UNITED STATES PATENT AND TRADEMARK OFFICE

APPLICATION NO.	FILING DATE	FIRST NAMED INVENTOR	ATTORNEY DOCKET NO.	CONFIRMATION NO.
09/343,509	06/30/1999	YOSHIAKI TAKABATAKE	0039-7268-2R	8009

**Office Action Summary**

## DETAILED ACTION

*Figure 1: Sun workstation configured as a router*

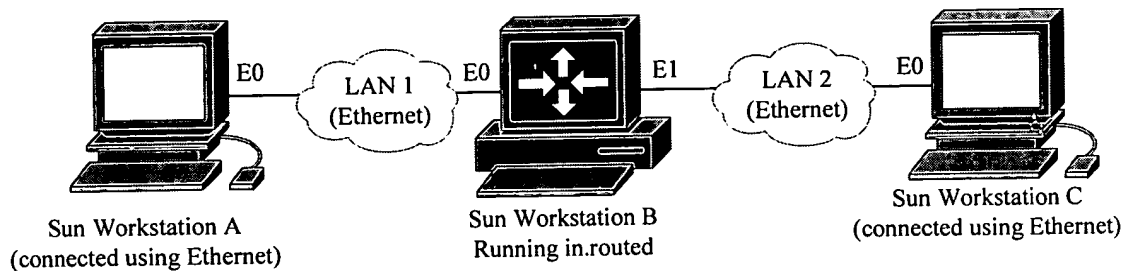
*It is well known to a skilled artisan prior to applicant's invention that one node made be connected in such a way as to bridge two networks together. This communication node (or gateway node) further comprises functional units such that nodes in a first network may communicate with nodes a second network. By way of example, figure 1 illustrates this very point. Shown in figure 1 is a sun workstation B configured as a router such that a workstation A in network 1 (i.e., LAN 1) may communicate with a separate node (i.e., workstation C) in a different network (i.e., LAN 2). This is accomplished by running the in.routed daemon on workstation B containing two network interface cards (NIC), one for each network connected to an Ethernet*

*interface shown as E0 and E1 (i.e., a first interface unit and a second interface unit) as is known by a skilled artisan prior to applicant's invention. As defined by a router, networks are separated logically by their logical address or IP address.*

*Hence workstation B is able to recognize (i.e., it contains a recognition unit) one communication node (i.e., workstation A) on the first network as one of its "constituent elements" (since it has the same network address). Also disclosed in workstation B is a configuration information disclosure unit for letting workstation C know about workstation A. Examiner notes this can be accomplished many different ways, for example, using either an ARP query or a network service (e.g., NIS). In addition, a skilled artisan can furthermore execute various Solaris commands (i.e., applications) remotely for determining specific configurations of various nodes in either a first or second network (making the two networks seem transparent). Therefore it would have been obvious to a skilled artisan that given this very common configuration, that a workstation A in network 1 can communicate with a workstation C in a separate network via a communication node, workstation B, such that the interaction appears transparent to the end user. In other words, examiner notes no mention of an IEEE 1394 (i.e., firewire) network or bus disclosed in the claims such that the functionality as disclosed*

by the applicant in general would have been obvious to a skilled artisan given other types of networks and protocols such as using Ethernet operating on a bus topology as shown in figure 1.
